City of Rohnert Park  
Public Works Department

DATE: SEPTEMBER 5, 2025  
TO: ALL PLANHOLDERS  
SUBJECT: CITY OF ROHNERT PARK  
BENICIA PARK CONCESSION STAND RENOVATION  
PROJECT  
NO. OF PAGES: 13

### ADDENDUM NO. 1

BENICIA PARK  
CONCESSION BUILDING  
FIRE REPLACEMENT  
7471 BERNICE AVENUE  
ROHNERT PARK, CA 94928

**A2.05**

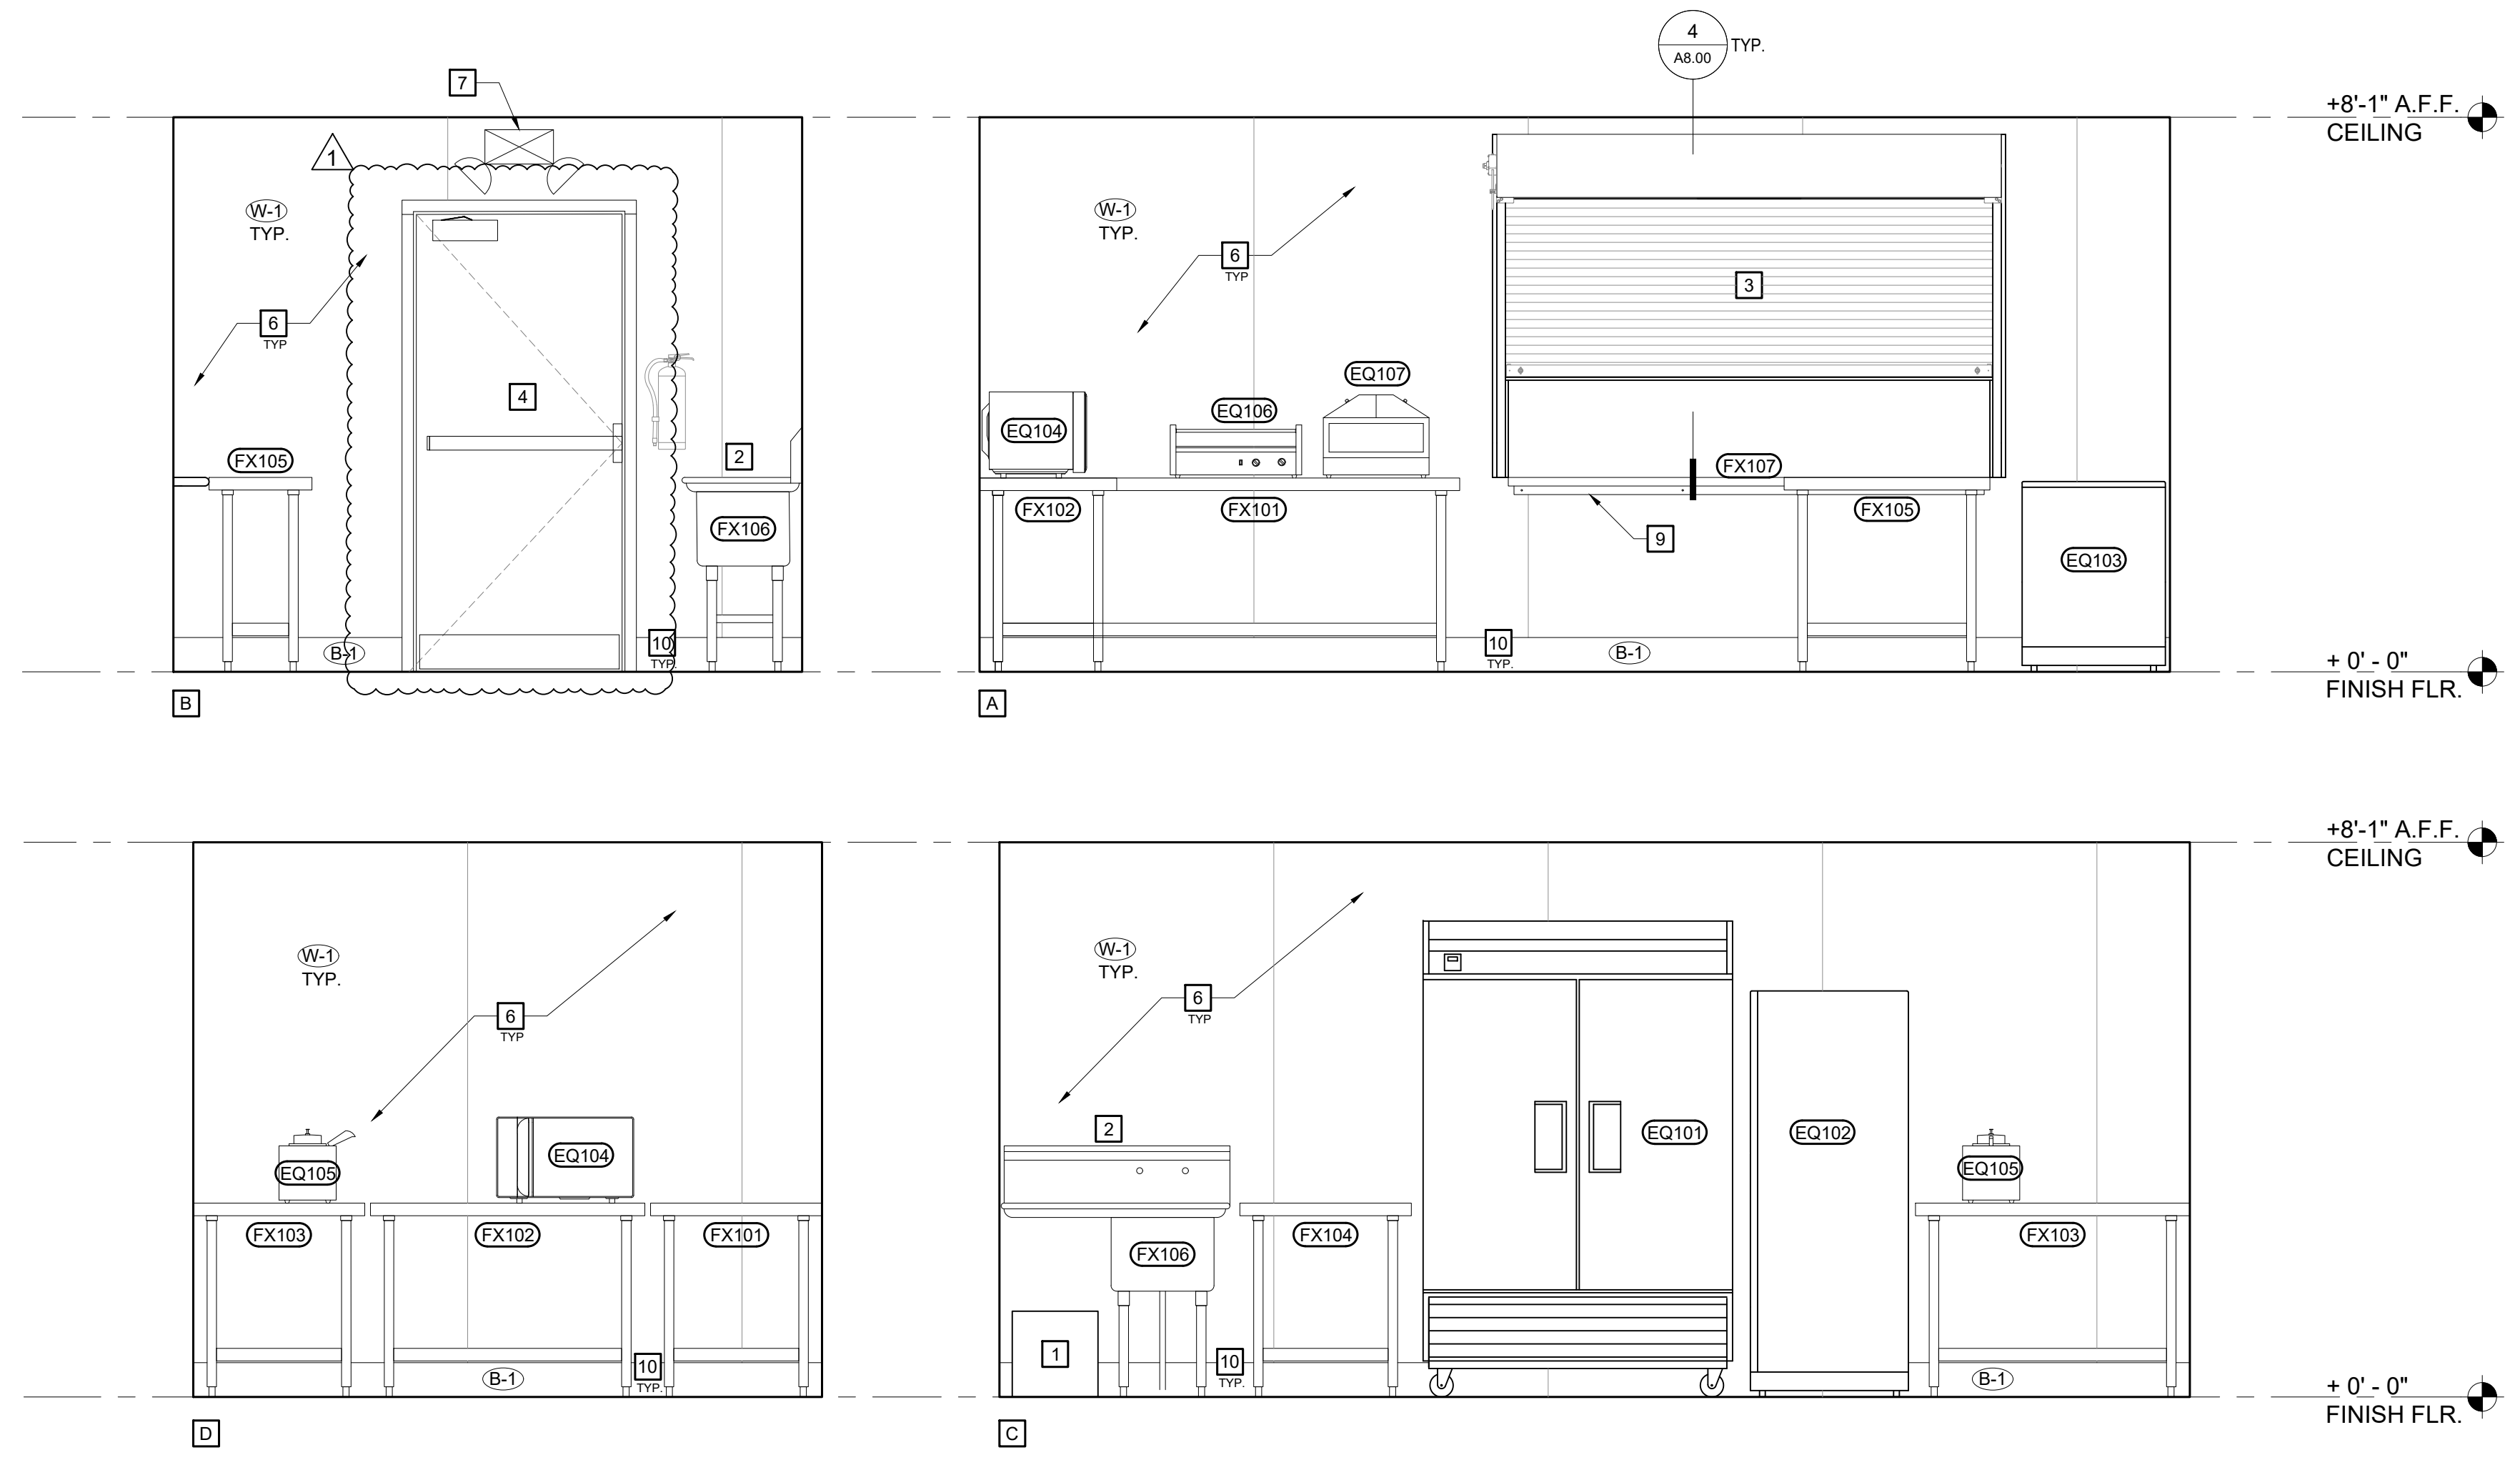
### **Sheet A2.05**

- Updated door hardware to reflect Push Rail and Lever Hardware
- Door Schedule has been updated from Hardware Set 2 to Hardware Set 1

# A3.00

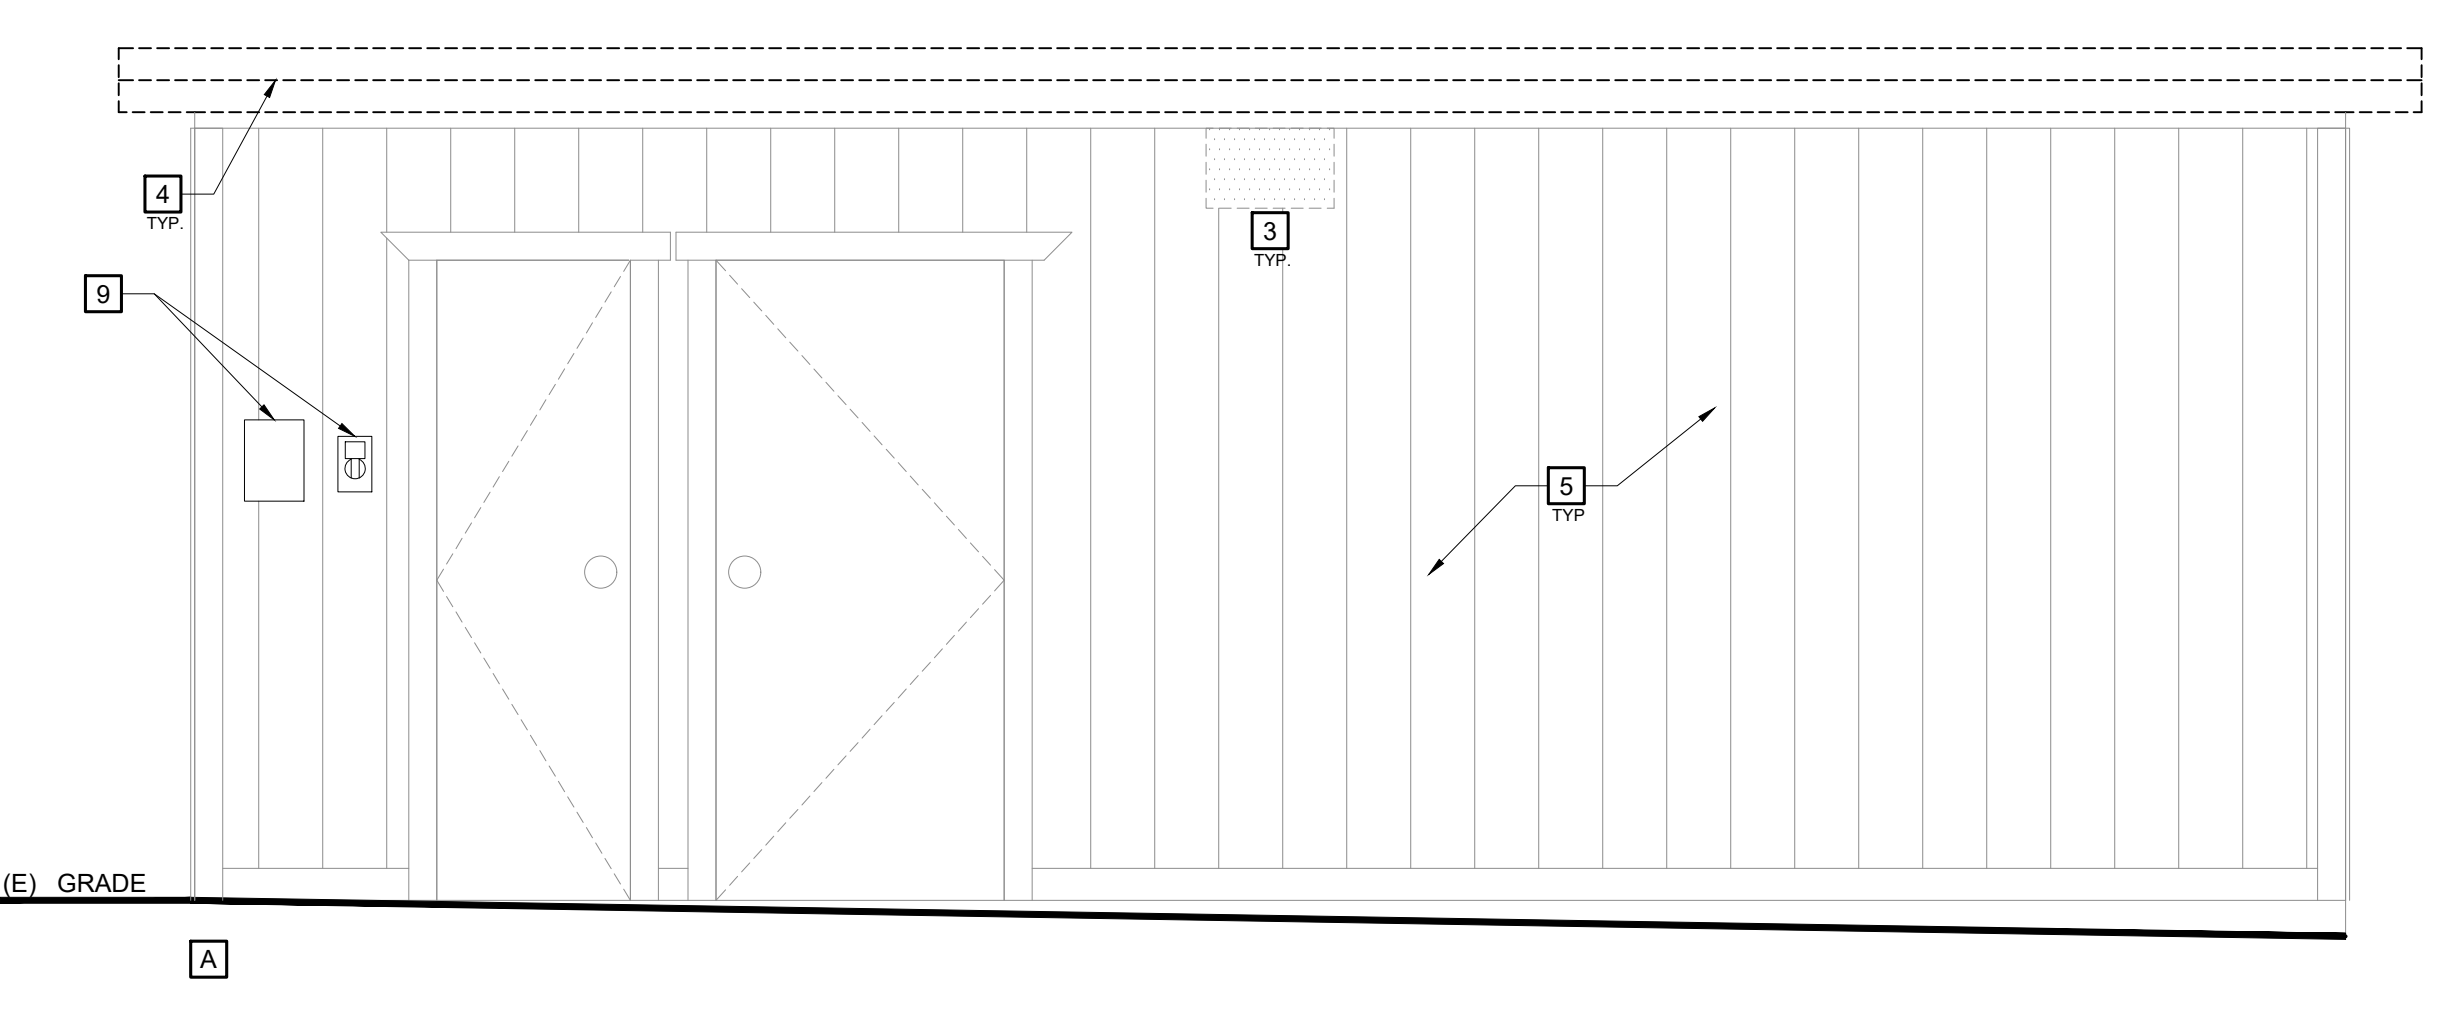
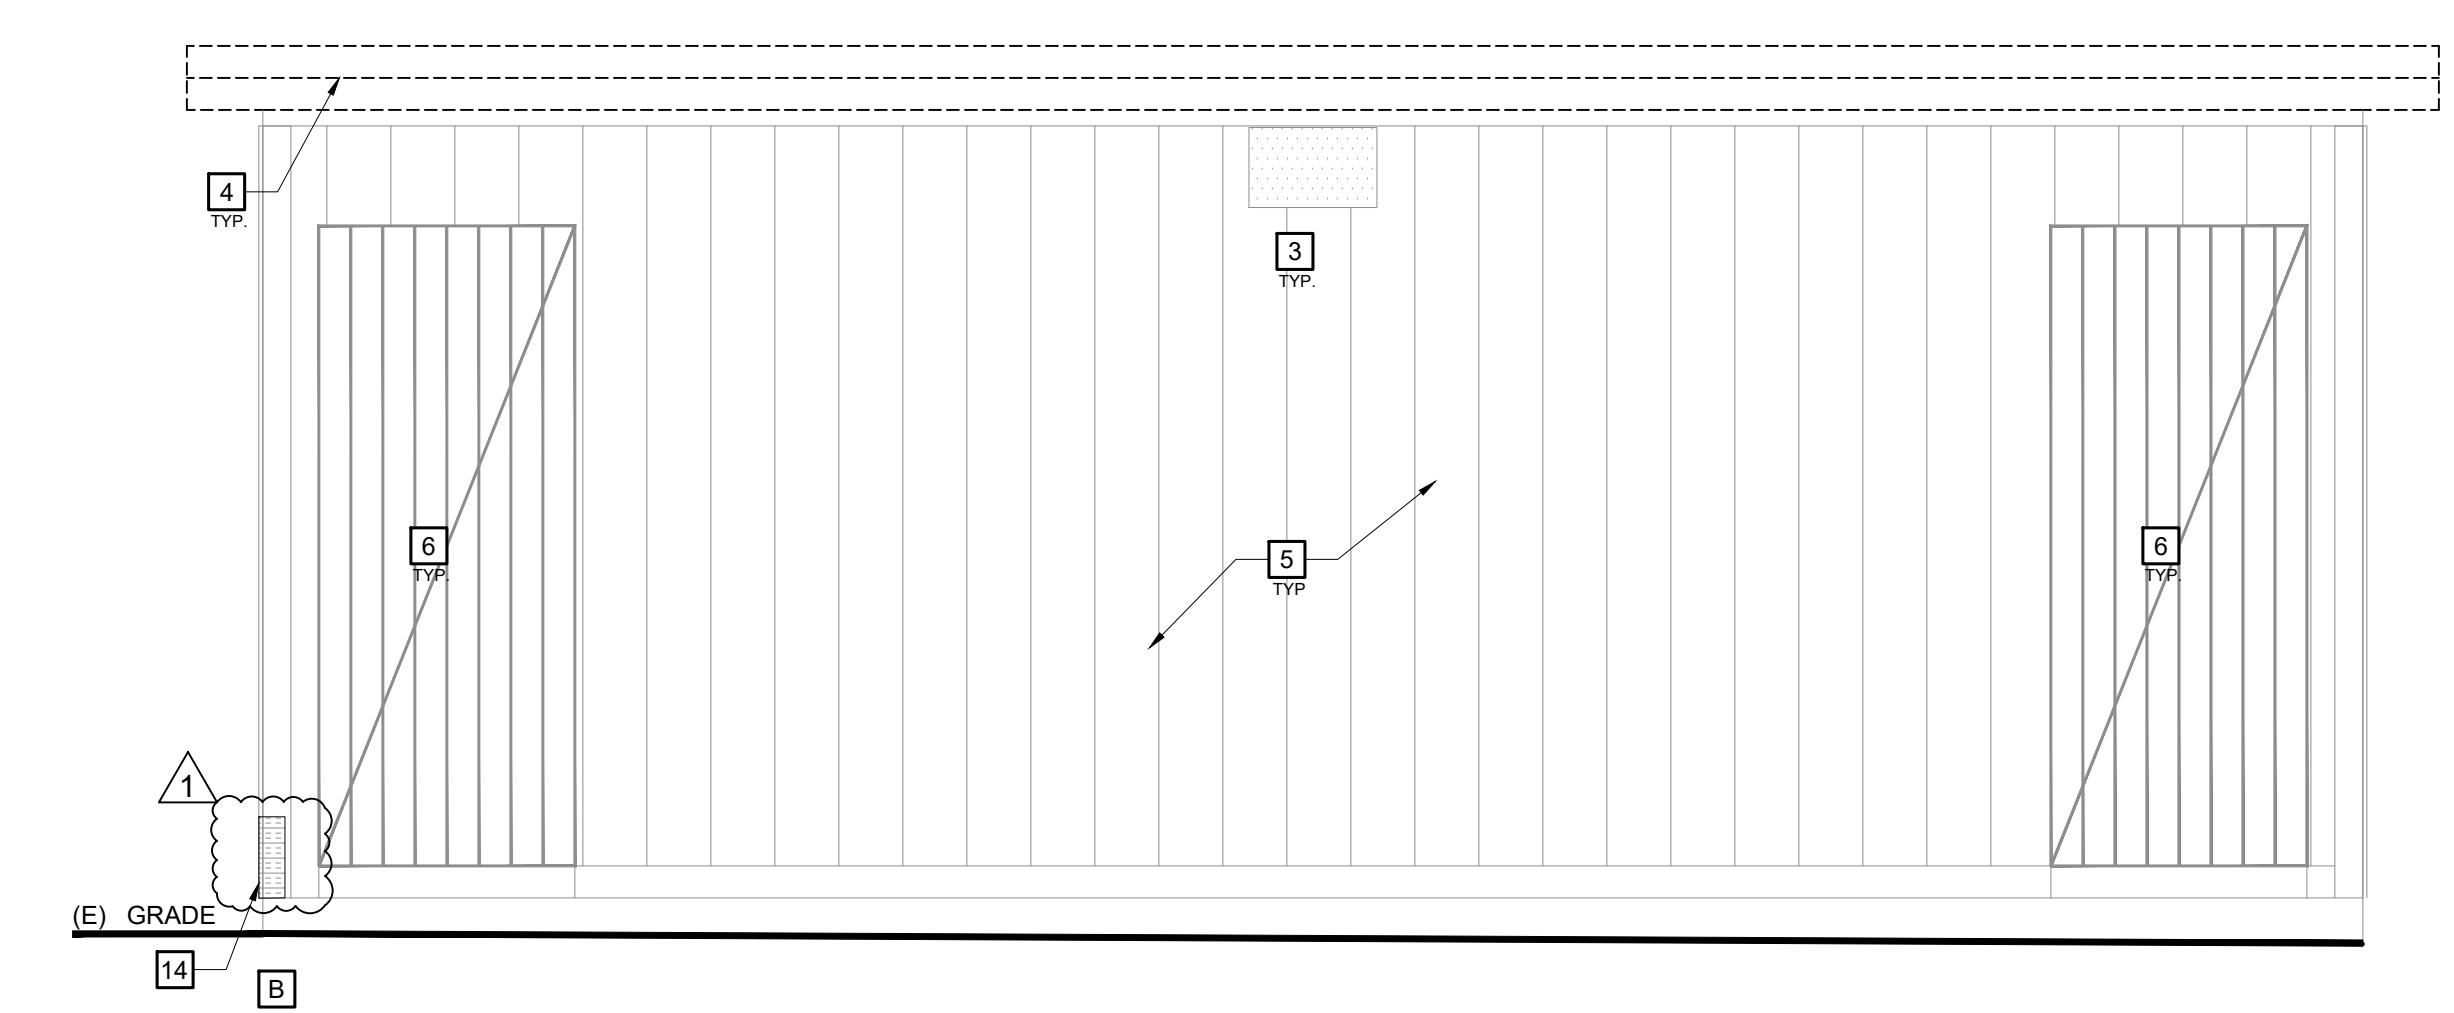
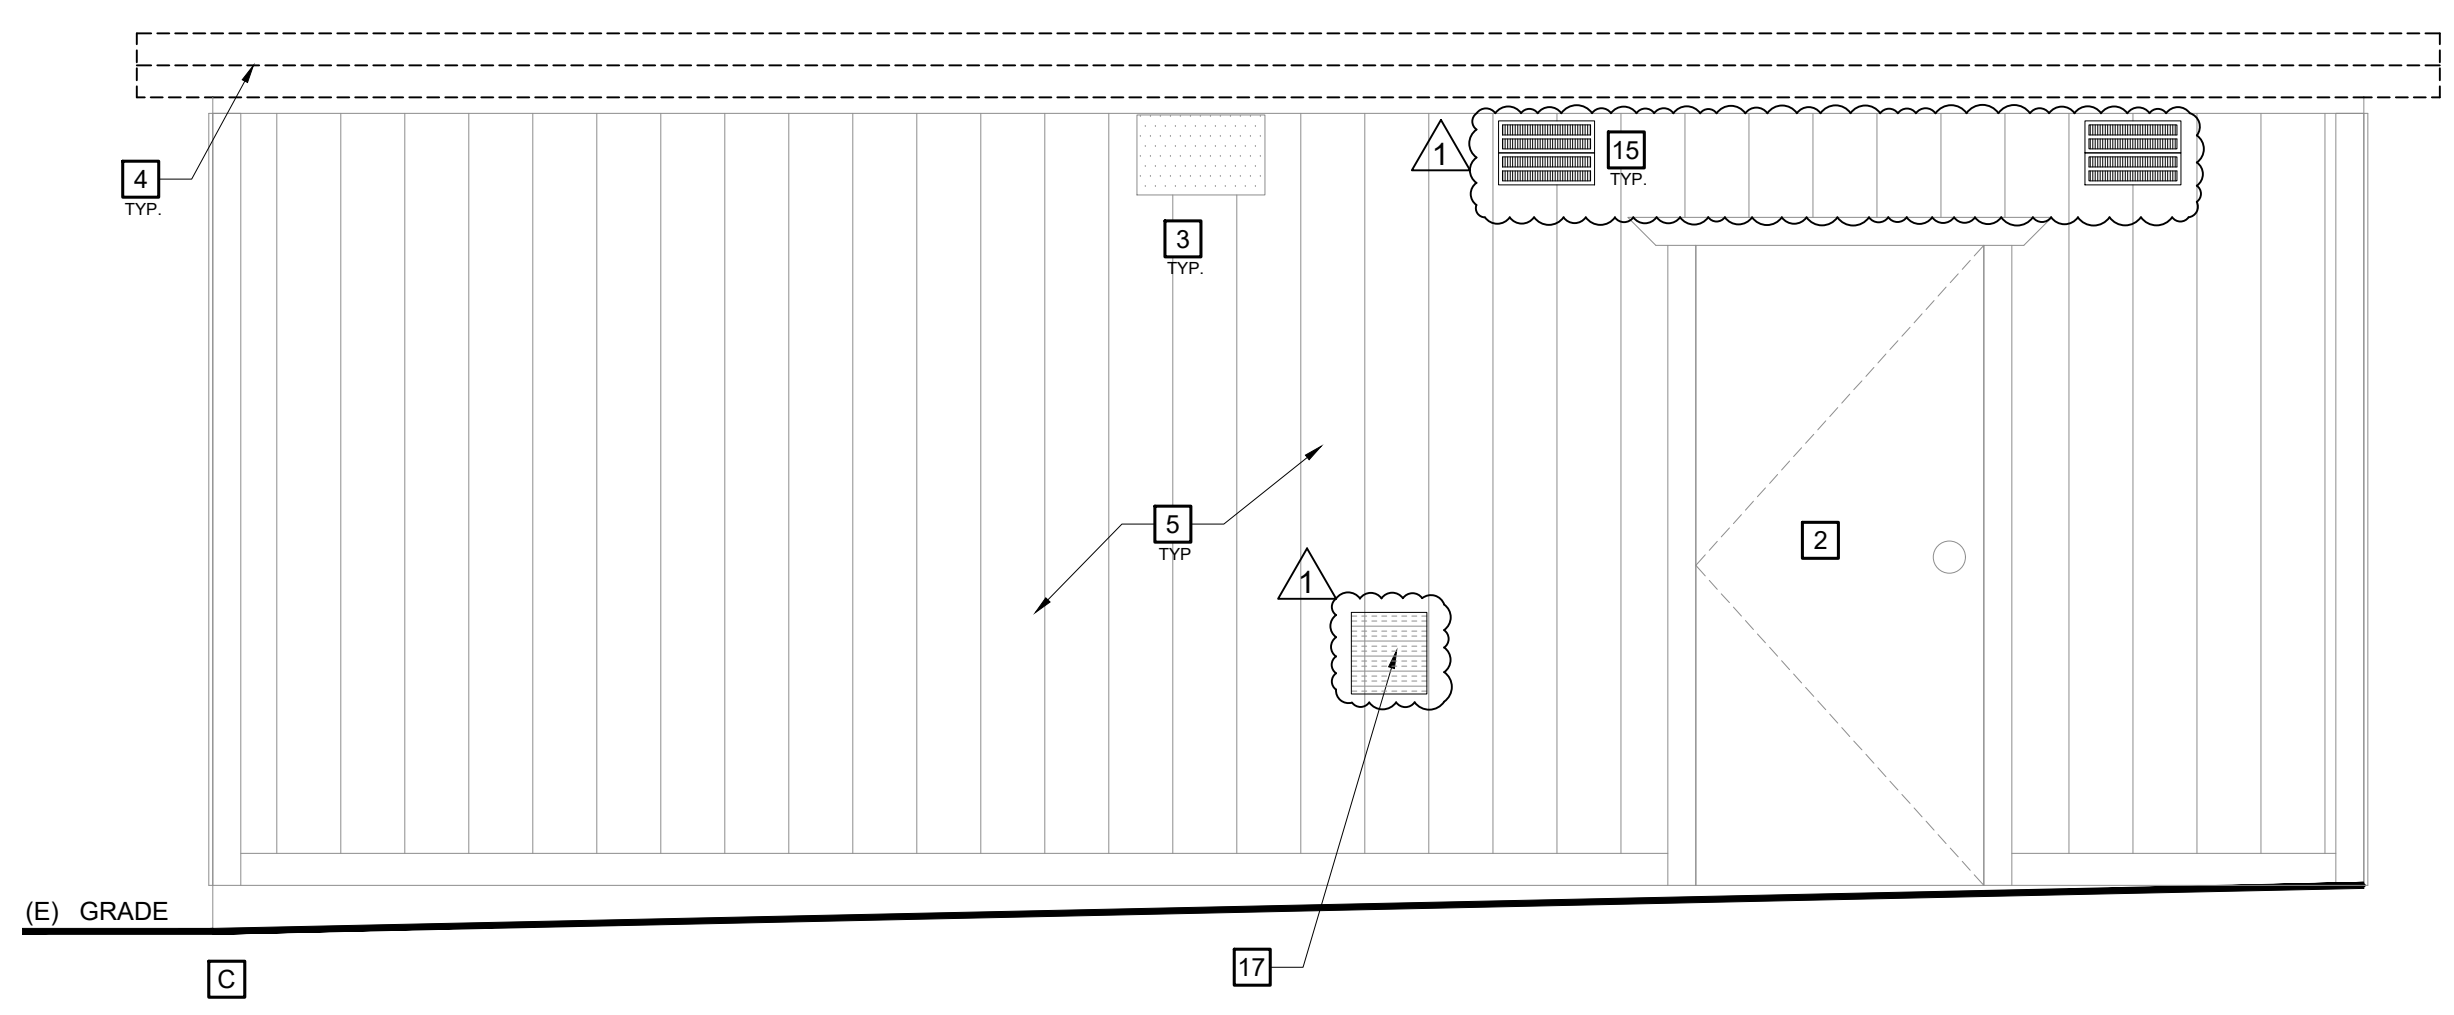
### **Sheet A3.00**

- Dry rot repairs
- Remove and replace fire damaged vent covers
- Remove metal plates and repair siding
